REMARKS/ARGUMENTS

Appl. No. 10/622,082
Amdt. dated October 18, 2005
Reply to Office action of July 18, 2005

Title: INFLATABLE SUPPORT SYSTEM

Fig. 3

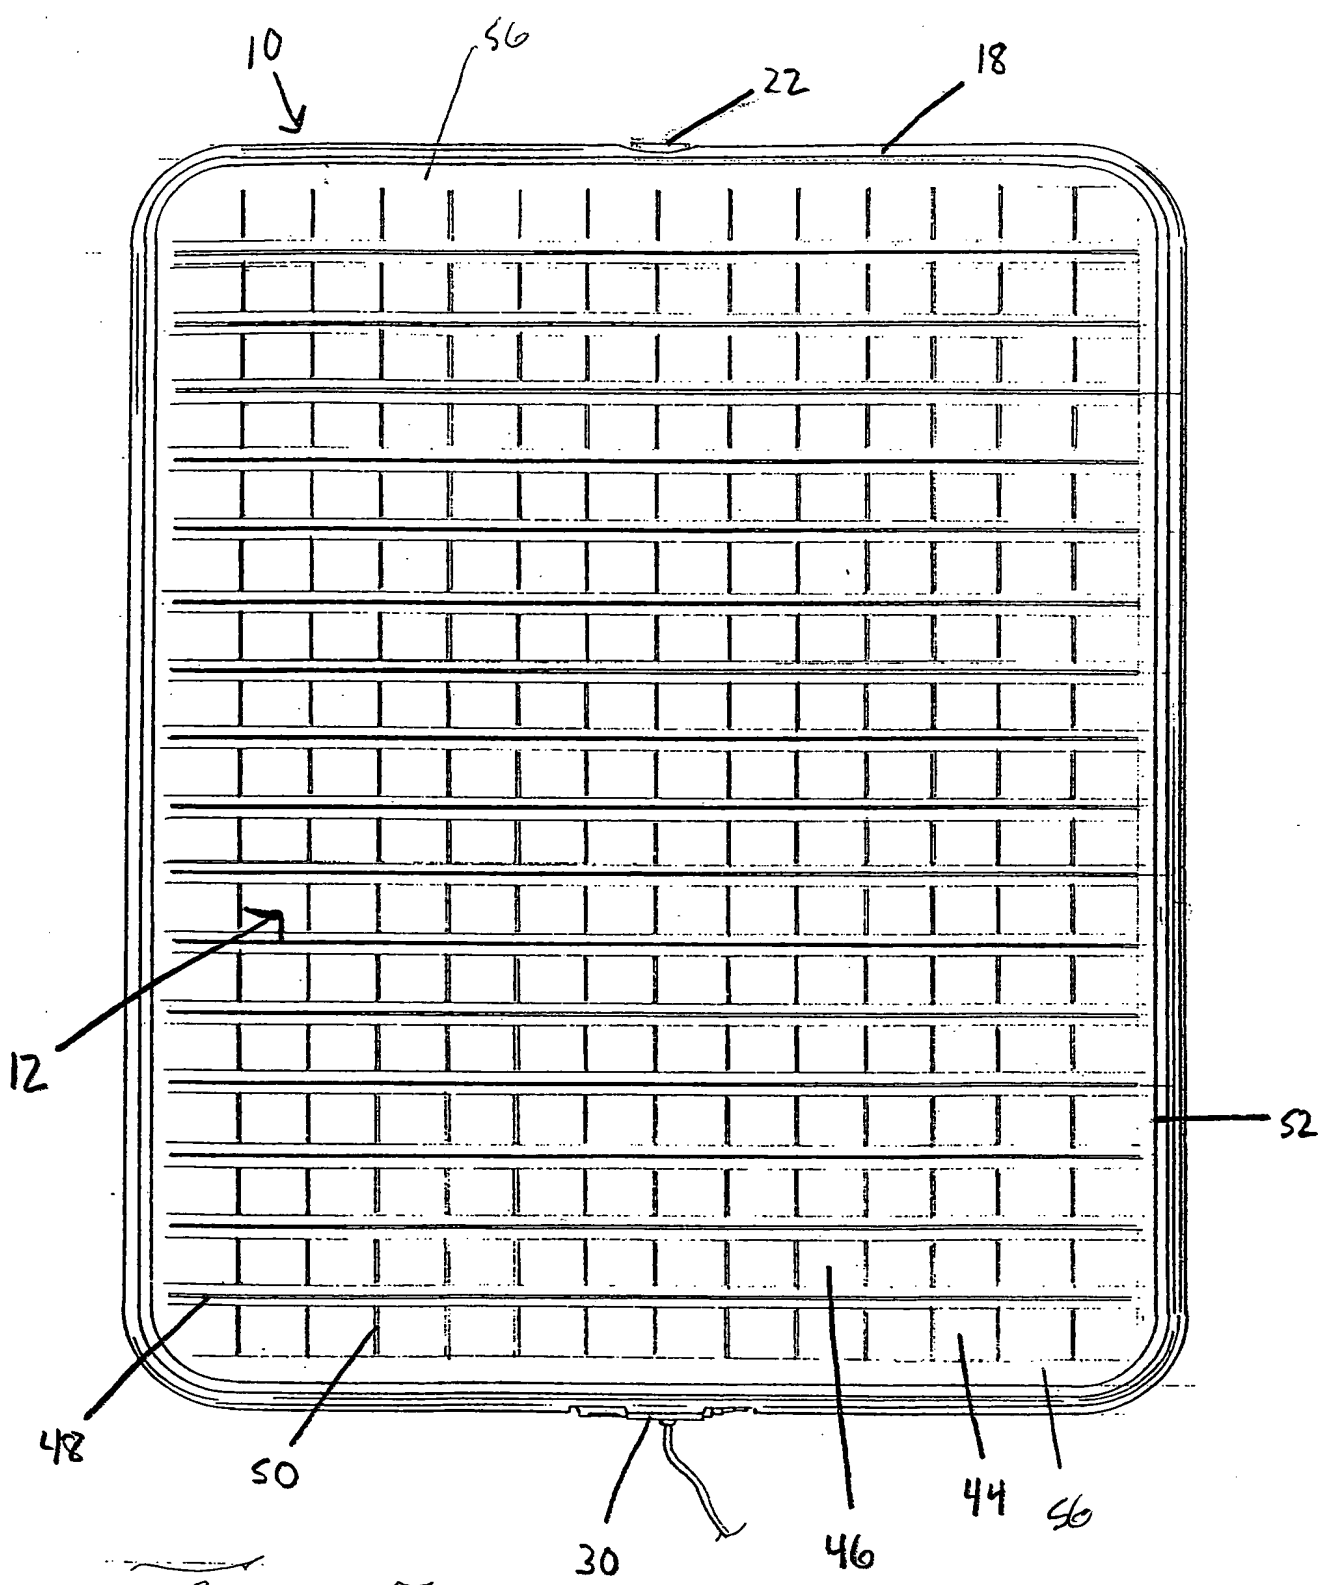
The Examiner has objected to the drawings because they do not contain reference numbers 45 and 56. Paragraph [0038] has been amended to correct a typographical error. The reference numeral "45" should be reference numeral "46." Figure 3 has been corrected to add reference numeral 56 to the figure.
